Application by National Grid Electricity Transmission (NGET) for an order granting development consent for the South East Anglia Link (Sea Link) Project

Examining Authority's Third Written Questions (ExQ3) Issued 24 March 2026

Examining Authority's Third Written Questions (ExQ3) Issued 24 March 2026

Section B

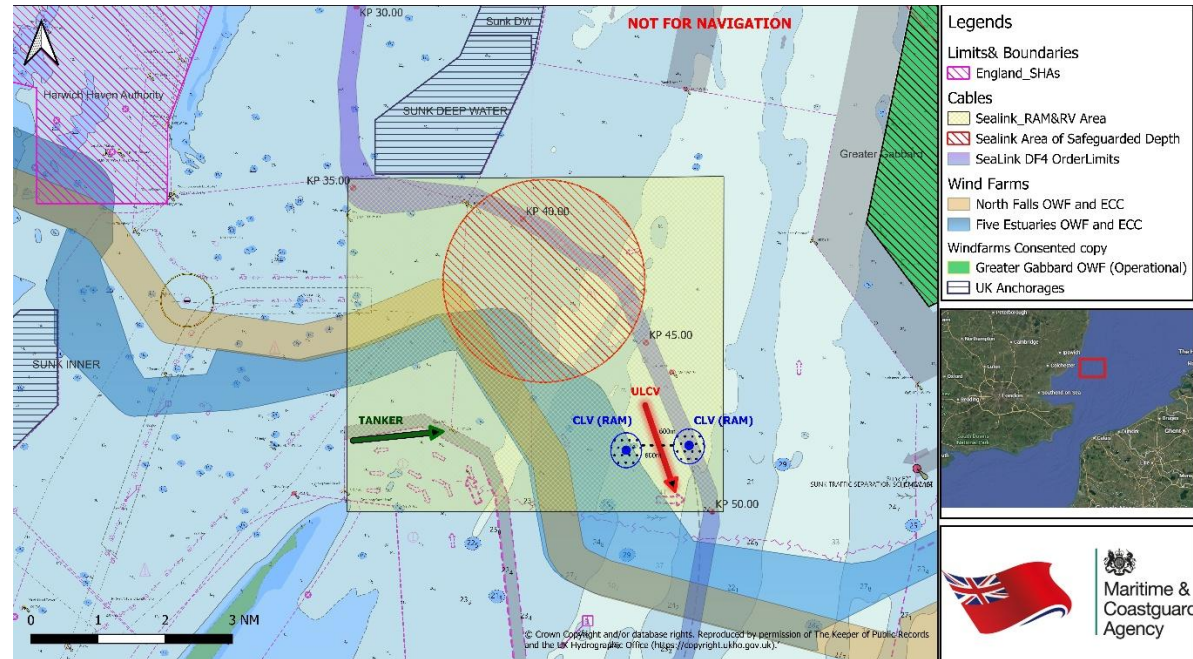
In the above example, two Cable Laying RAM vessels (blue) are operating in each of the cable corridors (Sealink and Five Estuaries), within the Long Sand Heads two way route: a tanker (green) is –outbound using the northern part of the LSH route (allowing for the migrating sandbank), after dropping pilot, the outbound Ultra Large Container Vessel (red), is forced to proceed southbound between the RAM vessels meaning that the resultant distance to the 500m Recommended Restricted Zone is 600m which is only 1.5 times the vessel length (400m LOA) of an ultra large container. The average turning circle of such a vessel is at least 3-4 times the ship length and the stopping distance is approximately 3-5 ships length depending on various factors including draught, windward area, weather and sea conditions. This scenario is not factoring in any additional traffic like another out bound vessel (slower) ahead of the

<p>container vessel and recreational vessels crossing through the precautionary area in a SE direction, this will further complicate this scenario and may result in multiple close quarter situations within the precautionary area.</p> <p>Therefore, we believe that the current area of concurrent activities as captured within the NIP does not reduce the risk to navigation safety in this area to ALARP and therefore we don't agree that the residual risk is ALARP for vessel Collisions listed in Table 4.7.A.1 Hazard Log of the NRA. Within the additional mitigation measures column, it is listed that "Coordination of operations involving RAM within the Sunk, avoiding concurrent operations with other projects in the Sunk where possible" which is what the MCA are trying to achieve through the concurrent RAM activity area shown in Fig.1 of MCA submission [REP4-164]. Furthermore, within the oNIP submitted by Five Estuaries OWF and North Falls OWF during their Examination, it was clearly identified that the Navigation Installation Plan is a live document and therefore the document will be updated throughout the construction, maintenance and operational phase of these projects. It was also identified that there will be HAZOP workshops arranged by Five Estuaries and North Falls to discuss and agree concurrent RAM activities in the area, we believe these workshops will be a platform for Sealink to discuss and plan concurrent RAM activities in the area. Also, we note that based on the surface lay speed we received from the Sealink project team, the total time spent laying the cable within KP35-KP50 may be 17-24 hours and we believe therefore, that by adopting this wider area of interest, an agreement can be reached between all three projects to ensure smooth and safe operations in the area and thereby reduce the risk to navigation safety to ALARP.</p> <p>Suggested wording and plans to secure the concurrent RAM restrictions that the MCA seeks; to ensure no concurrent RAM activities take place within the MCA area of concern, the addition of this Condition which was provided as a post meeting note for MCA/Sealink meeting of 2/3/26 - sent on 17/3/26.</p> <p><i>Addition to para. 4(1)(g) of Part 2 of the DML along these lines.</i></p> <p><i>(g) a navigation installation plan for the relevant stage which—</i></p> <p><i>(i) is in general accord with the principles set out in the outline navigation installation plan;</i></p>

<p>(ii) must include a mechanism for agreeing with [the other developers] the dates when each will undertake RAM operations in the [defined area] and;</p> <p>(iii) may include provision that disputes under paragraph (ii) are to be settled by arbitration).</p> <p>This was discussed with the applicant on 30th March and is currently under consideration by the applicant.</p>
3SN4	MMO	<p>Cable burial Has the applicant's response in [REP5-132] to your concern in relation to cable burial depths from KP 96.343 to 113.83a [REP4-126] provided sufficient information? If not, what more do you require and why.</p>	<p>The applicant has confirmed the document referred to in REP5-132 is Document 9.126: Areas of Safeguarded Water Depth - Consideration of Additional Installation Requirements [REP5-139]. Within section 2 of this document, we note that the applicant has included details regarding additional trenching tools and seabed preparation mechanisms. Furthermore, through direct consultation with the applicant we understand that '<i>between KP 96.343 to 113.883, the ground model indicates the presence of sand waves and chalk bedrock, and the preferred installation approach is likely to involve pre-sweeping followed by mechanical trenching. Following further engineering assessment within the North East Spit Area, and specifically to maintain the Safeguarded Water Depth required by the ports, the Applicant has identified that the use of a backhoe deployed from a spud barge may be required over a limited section between KP 102.4 and KP 104.4. Over this restricted KP range, the installation methodology may involve pre-sweeping followed by backhoe trenching in order to achieve the depth of lowering required.</i></p> <p><i>The final target depth of lowering will be confirmed through the Main Works Contractor's detailed design, informed by engineering surveys and the burial assessment study. The Applicant has committed to updating the Cable Burial Risk Assessment (CBRA) post-consent. The final depth of lowering will be secured through the Cable Specification and Installation Plan (CSIP), which is in turn secured under DML Condition 4, and will be approved by the MMO prior to cable installation. The MCA is a named consultee for the CSIP and all relevant marine plans</i>'. Therefore, at this stage we believe the above additional considerations in cable laying along with post consent CBRA and CSIP would be sufficient to address the shallow burial between KP96.32 to KP113.883.</p>
